# **SERVICE BULLETIN: NEW EVFPK**

## **EFFECTIVE: 4/7/25**

### **To: Distributors and Certified Installers**

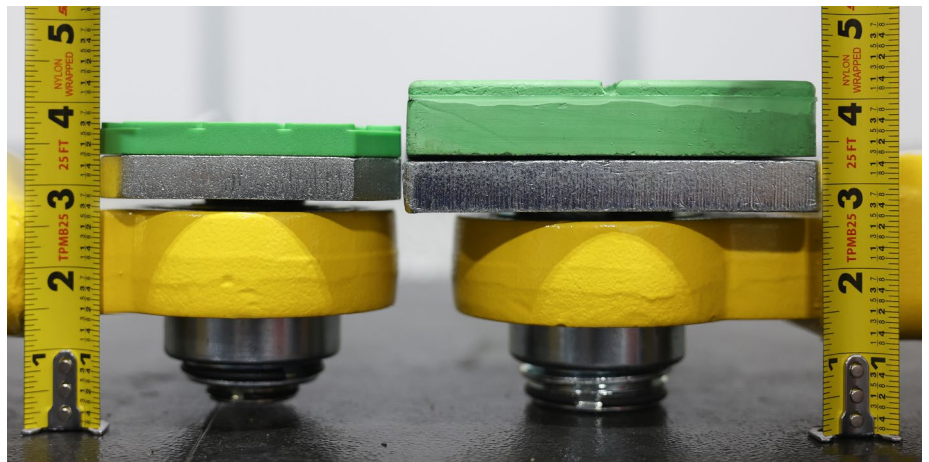
There has been a change/upgrade in the design of the footpad kit used for electric vehicle service. The current footpad kit (TFPK) will still be available. But the new P/N EVFPK, has been designed and implemented to aid technicians in quickly spotting and raising electric vehicles. The new EVFPK is ALI® certified with all of our 10K and 12K 2-Post and Inground lifts.

The TFPK was, in some cases, too tall to fit under vehicles and too long to fit in a particular pick-up point location.

- Lower than current TFPK
- Double screw-up for finer adjustments
- Fits in smaller spaces
- Pad is more durable and thinner
- Works well with luxury vehicles
